LAND USE APPLICATION

Project Description	adding a attached car & RV Garage. The garage needs to be 21.5 feet tall to fit the RV inside while maintaining to same roof pitch as home (sort looks nice). also we are requesting to build slightly into the seven foot easement on the east property line. we have drawn this to be 750 square feet or less.
Project Name	RV & Car Garage

Subject: Plans and possible Variance for Proposed car and RV garage at 945 Greenway Dr.

ELEVATION
SCALE @ 1/4" = 1'-0"

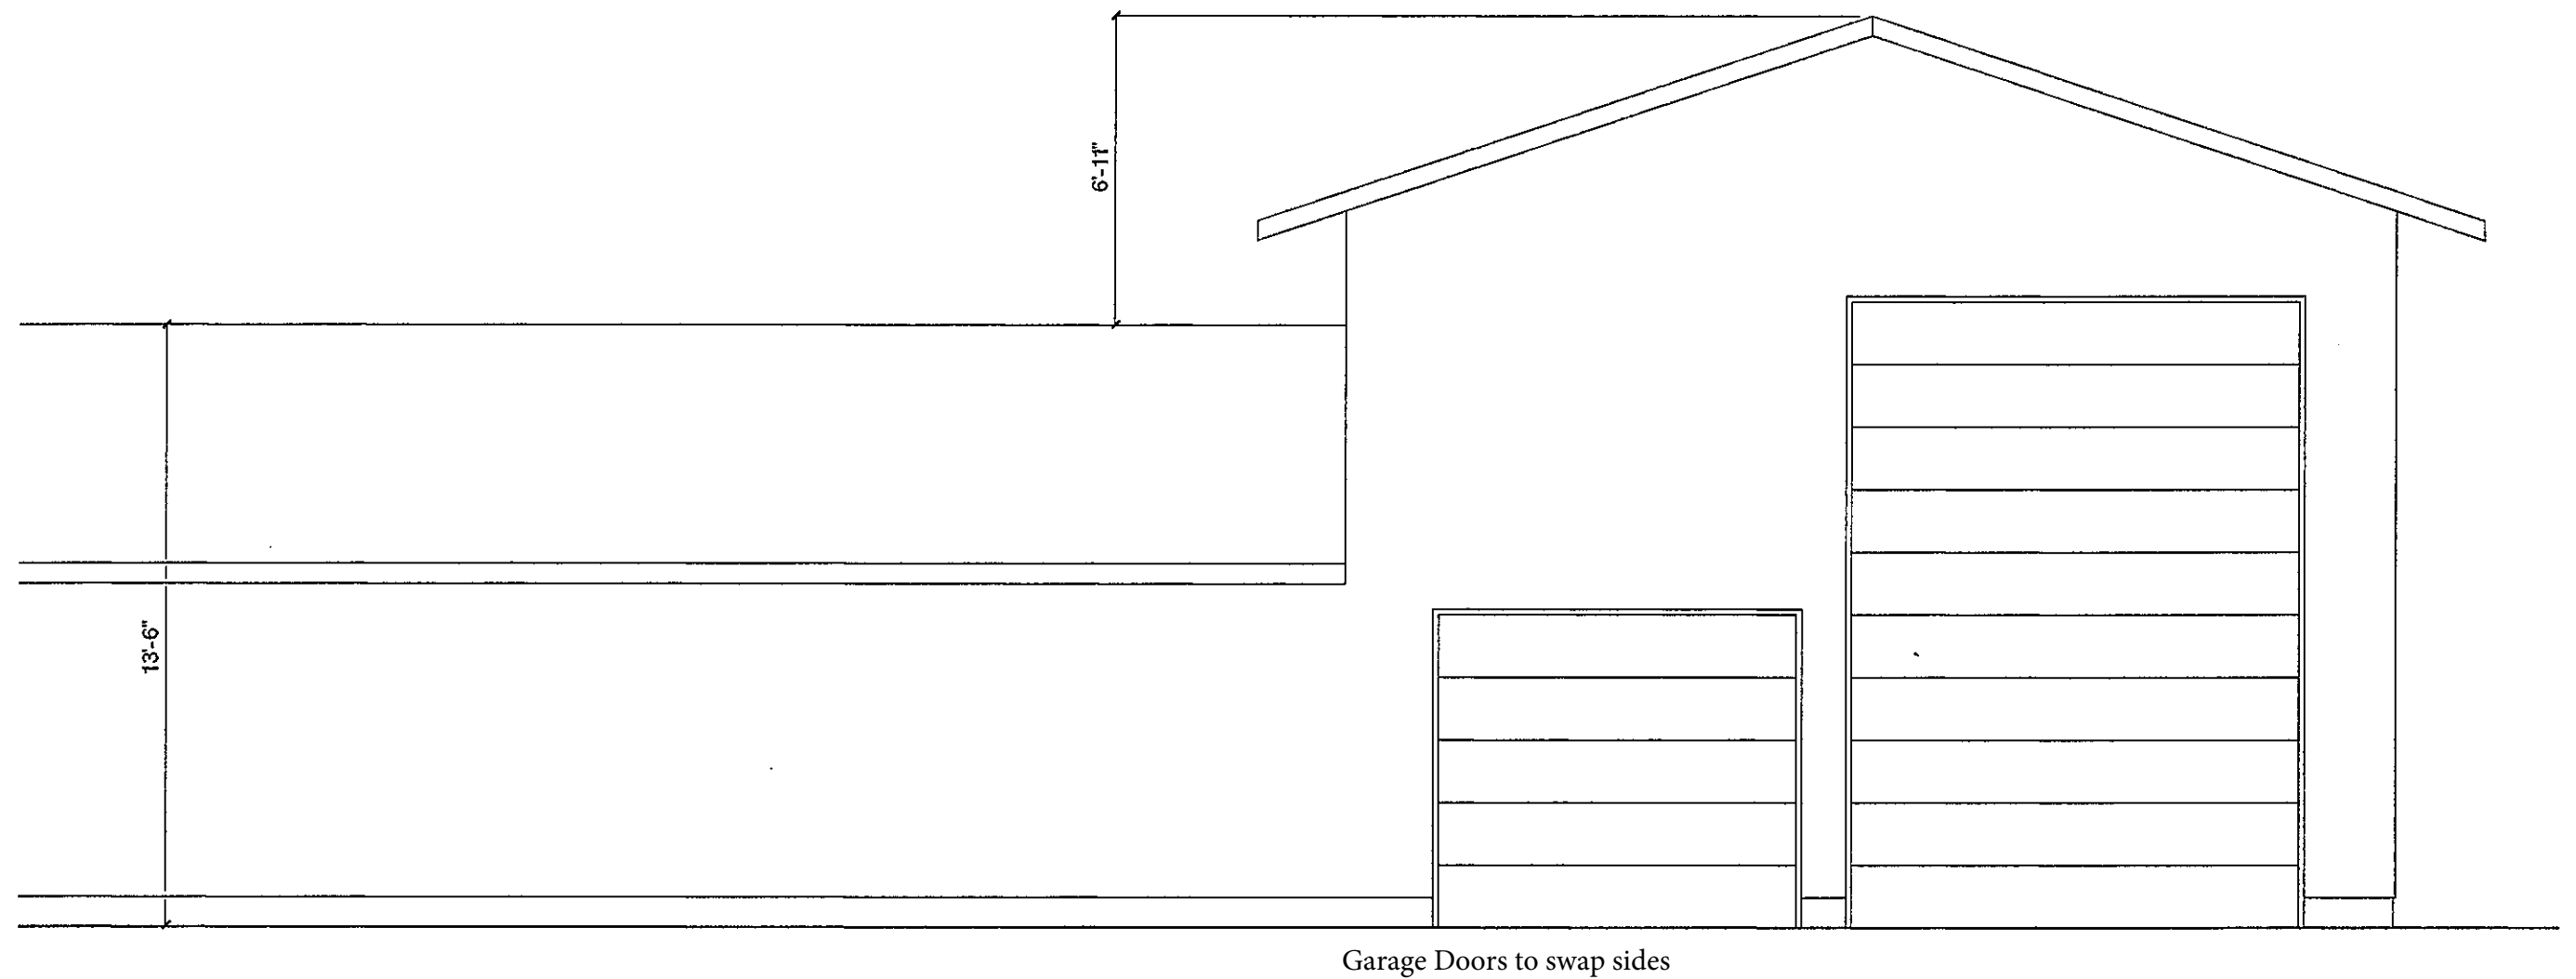
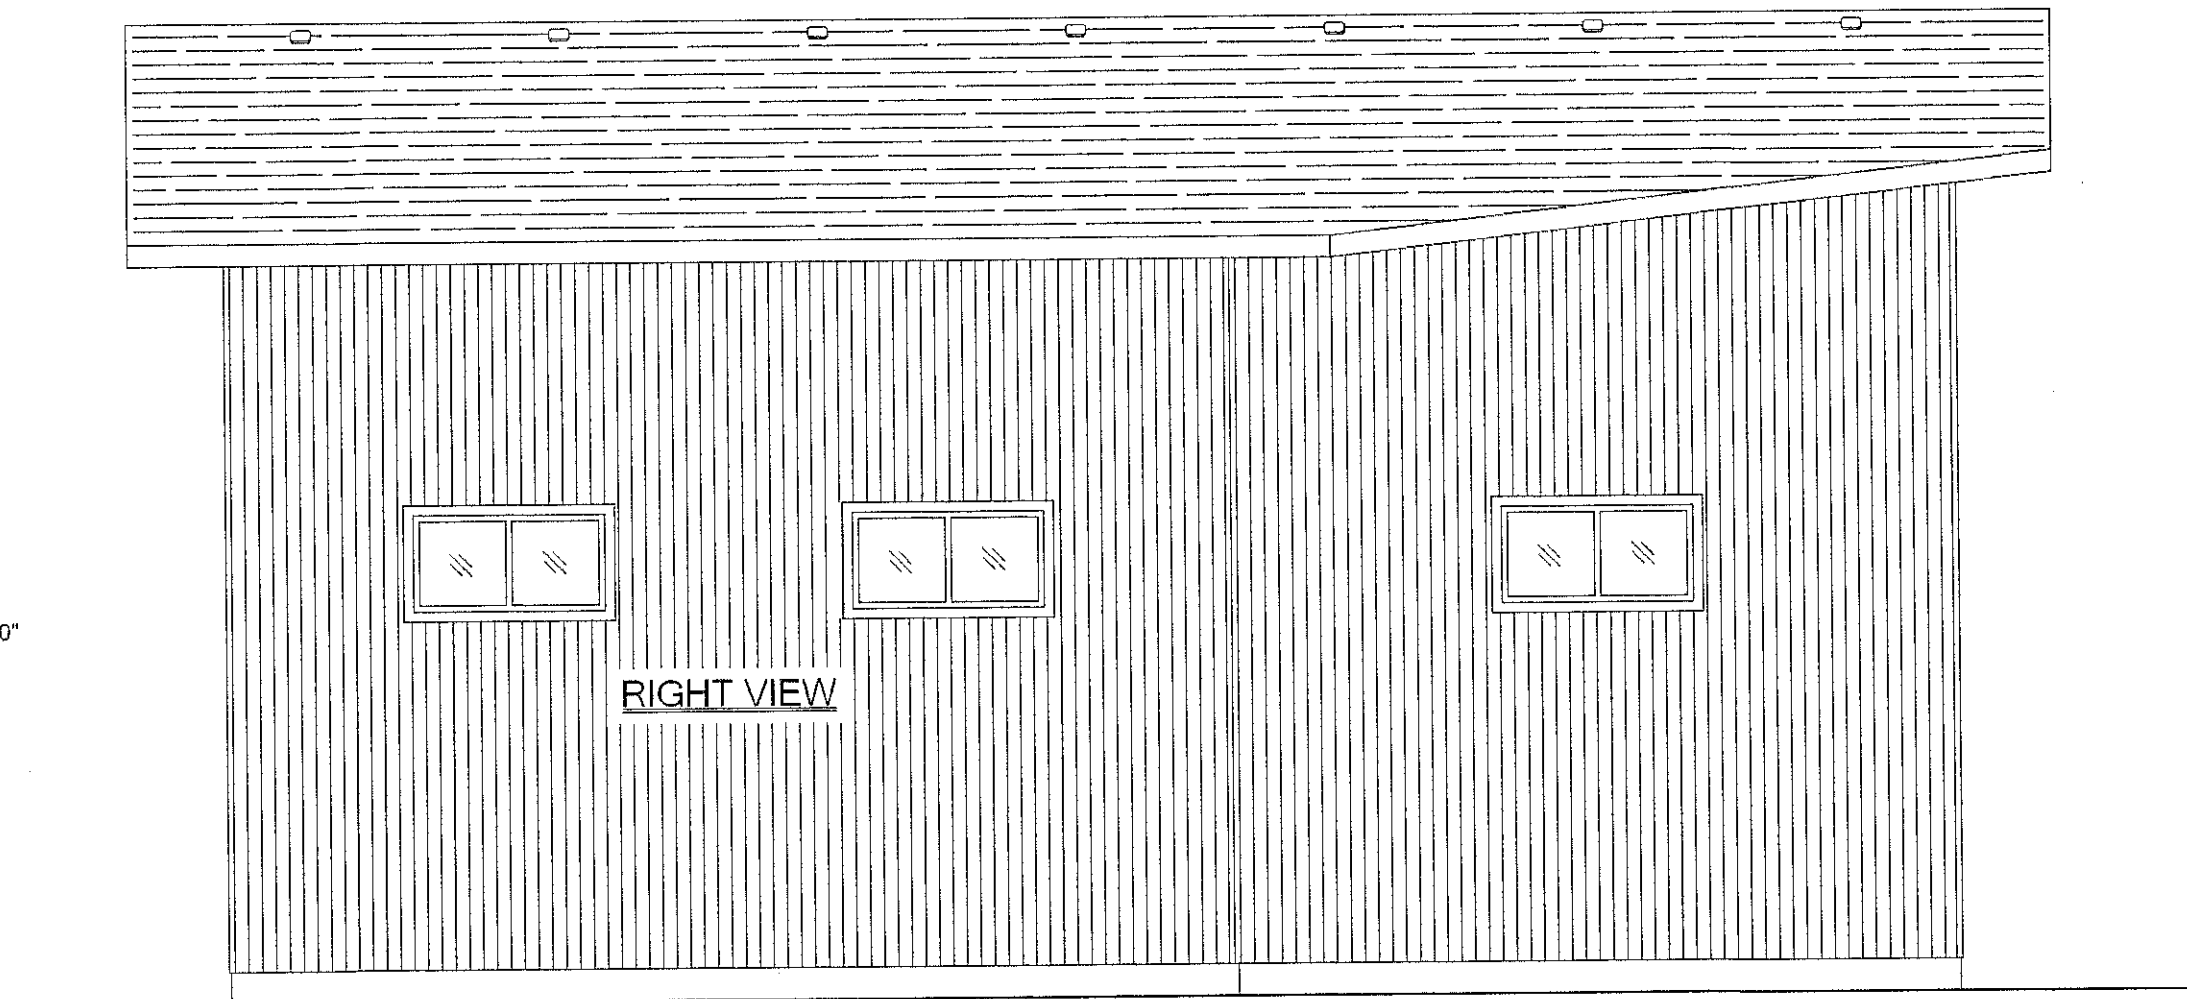
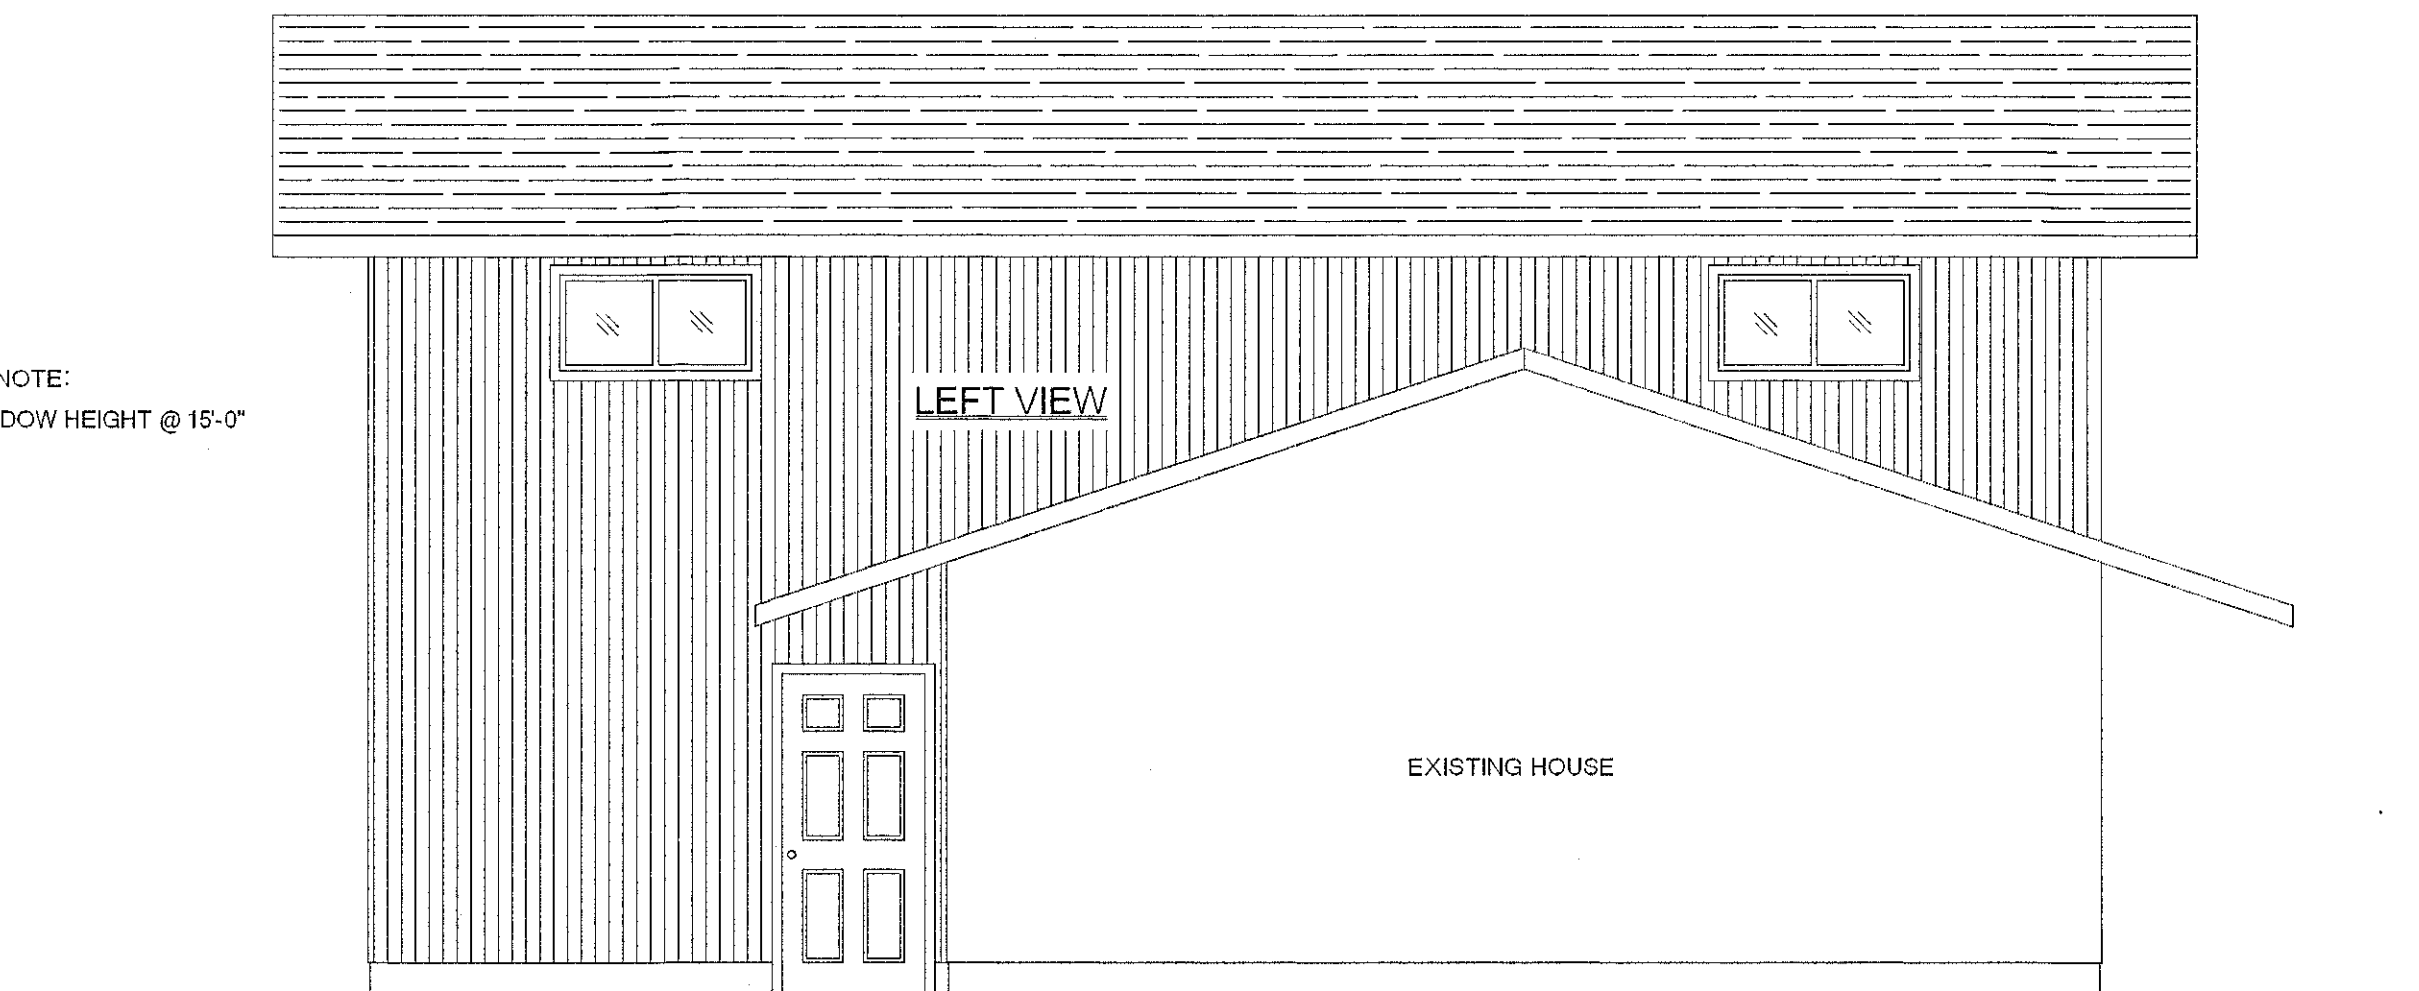
3. **Height Differential:** HMC 18.50.150(3) states that you can't exceed the height of the existing home, and 10' difference in this case is quite a bit. Again, I could allow you to adjust to a 13' height on the new accessory structure without a variance, but in this case, you would definitely need to request a variance. Class A motorhomes are generally 14' tall, and your 22' request exceeds that by a lot. You'll need to be prepared to address the reason why you need a structure that exceeds the height by that much. Again, given that you meet the rest of the criteria, you must be able to persuade the Planning Commission that there is some kind of special circumstance behind why you should be allowed that height.

As for the height, the maximum allowed in your zone is technically 35'. So yes, you can exceed the height of your home with a variance. It's better for property values to have homes similar in height near each other, which is one of the reasons why that limitation is in place as a general planning principle.

SITE PLAN

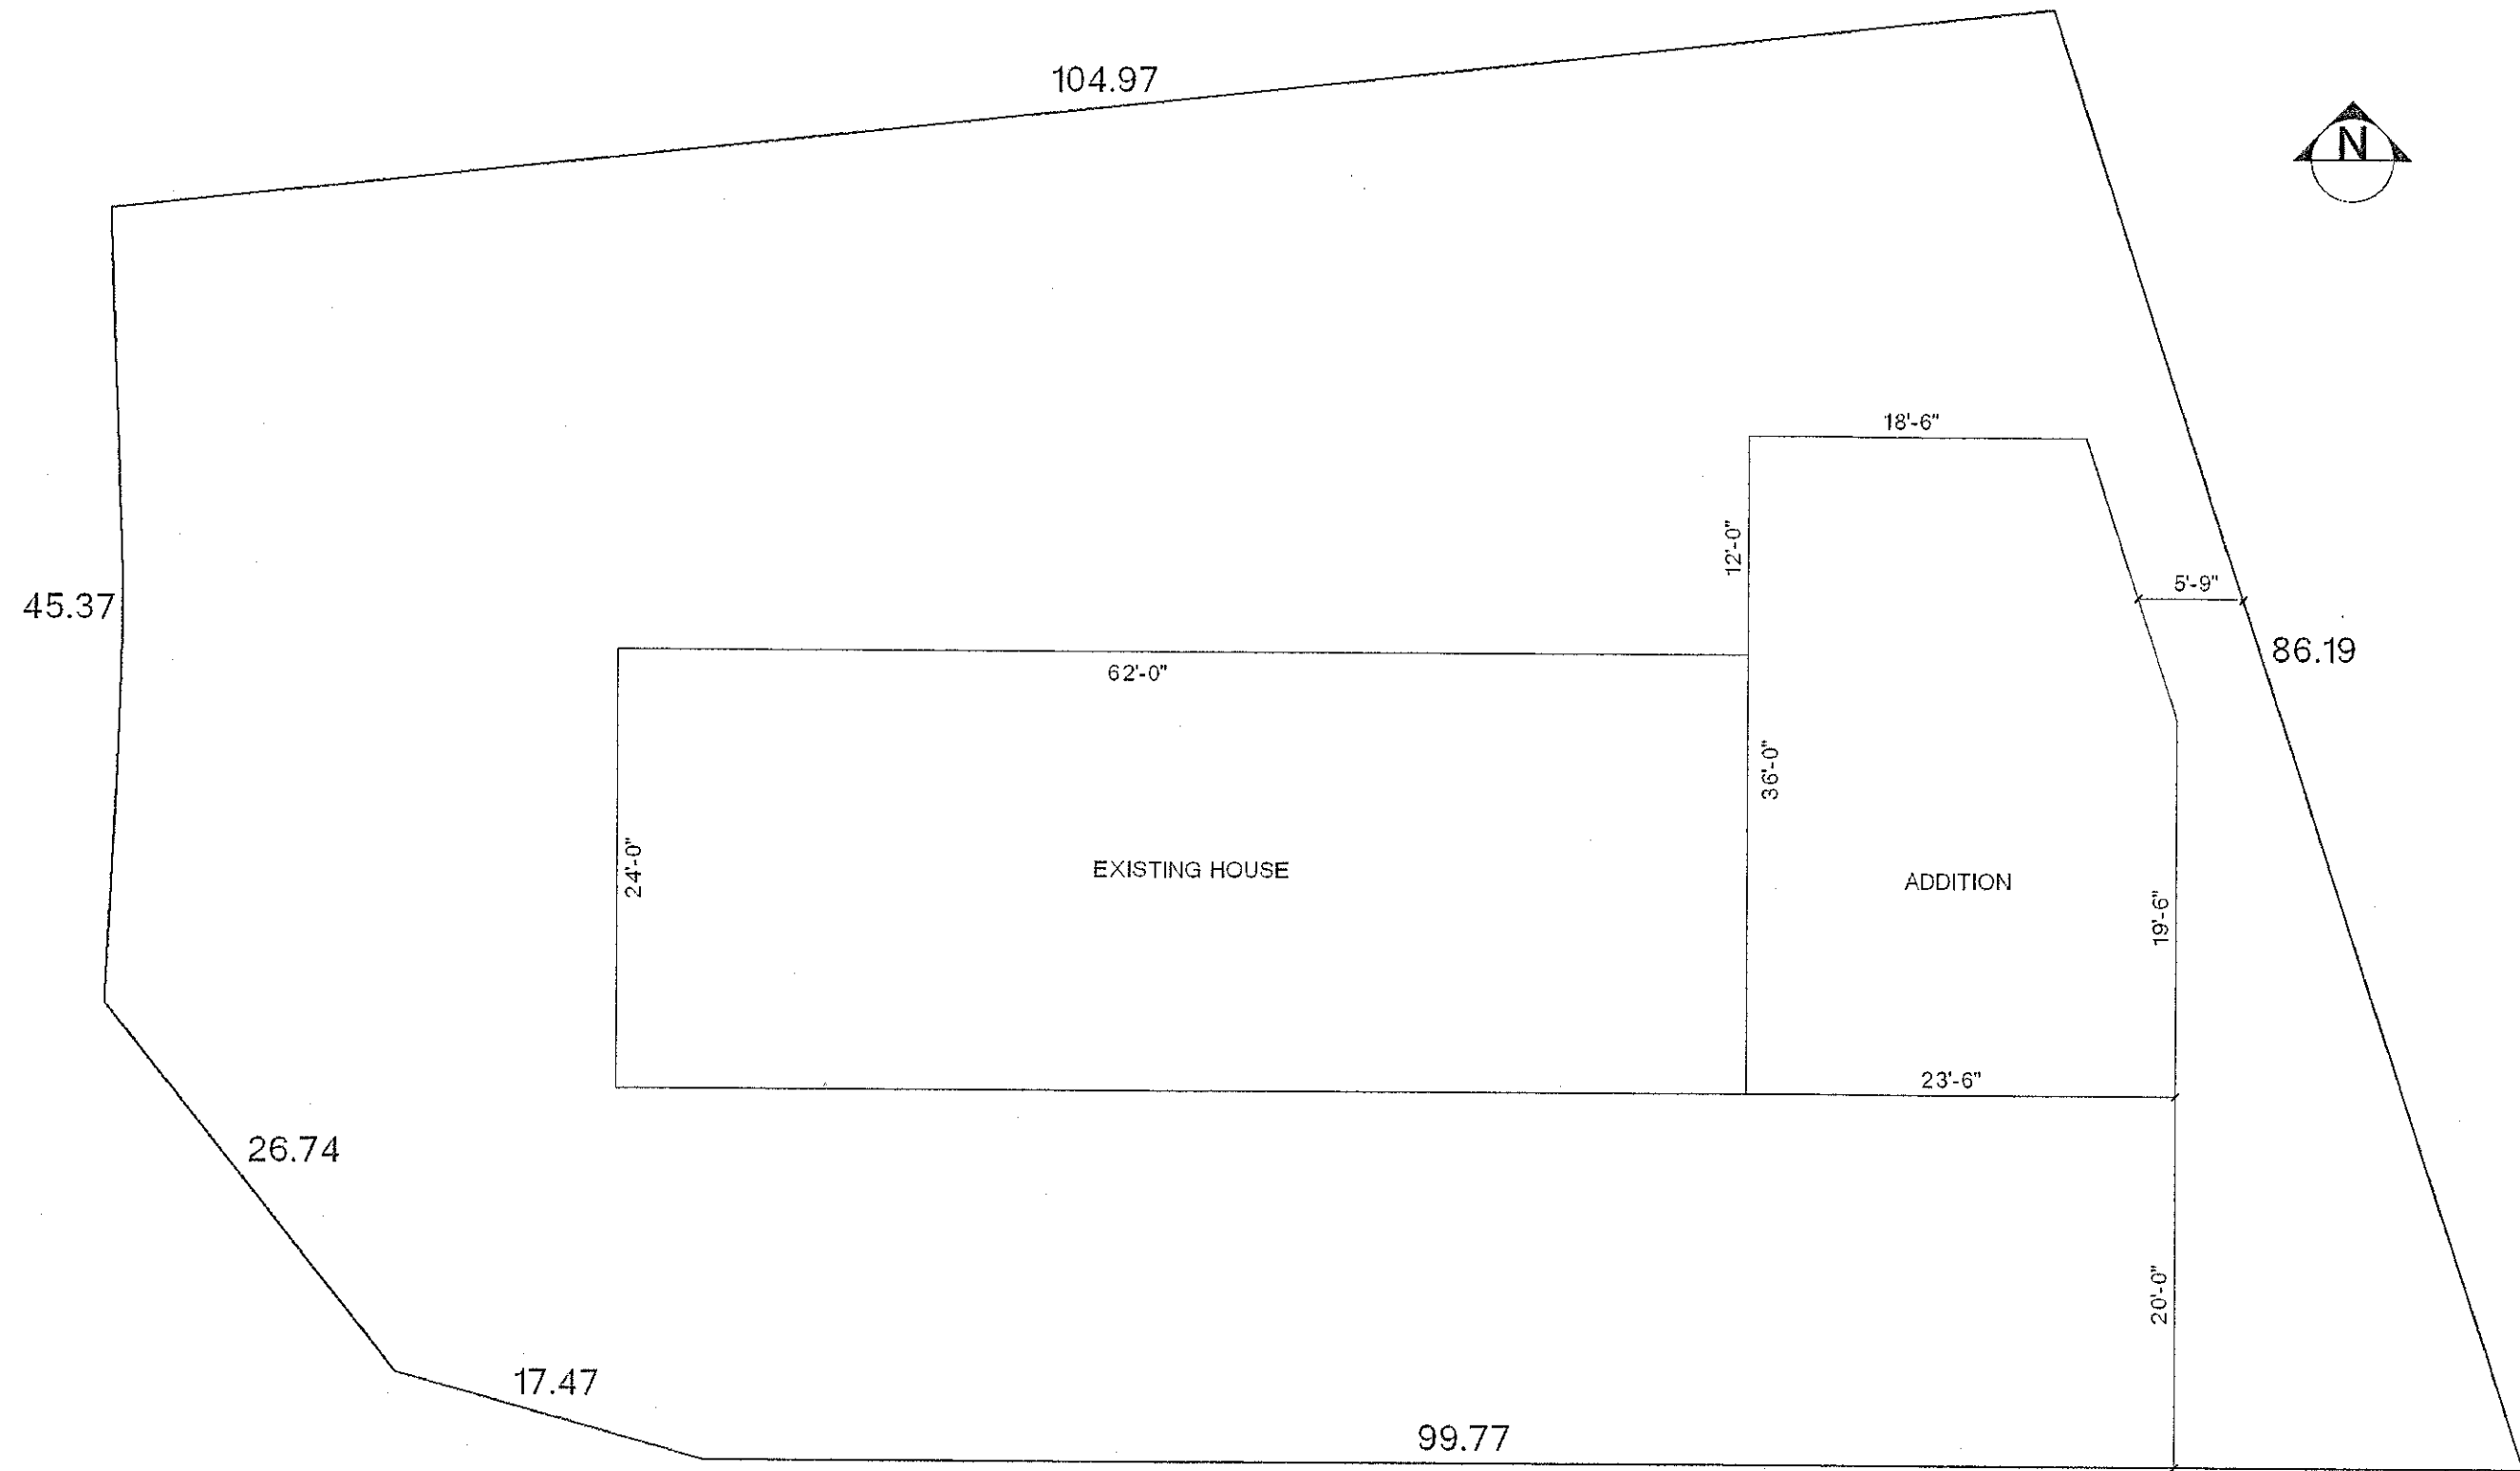
1. **Front Setback:** The plans you've brought would need to be adjusted, as there must be a 20' setback to the front of any garage. Throughout the code, it's 20' setback to the garage in this zone; therefore, we would have to recommend no variance to be allowed to apply to the setback in front of your proposed structure. (In the past, if your garage was 20' back, and you were filling in your garage on the home, I could allow someone to use the 20' area as their primary parking area...that's not the case here.) Unfortunately, the 20' setback for a garage is one that's pretty obvious throughout the development code. You can still ask for less, but my recommendation in my staff report considering the above would be to recommend not allowing it.

2. **Side Setback:** I could adjust your side setback to 5.95', without a variance. But your 5' request would require a variance. In this case, as we've already discussed, there are wetlands to the east of your property, so that would be in your favor, provided you met the remaining variance criteria.
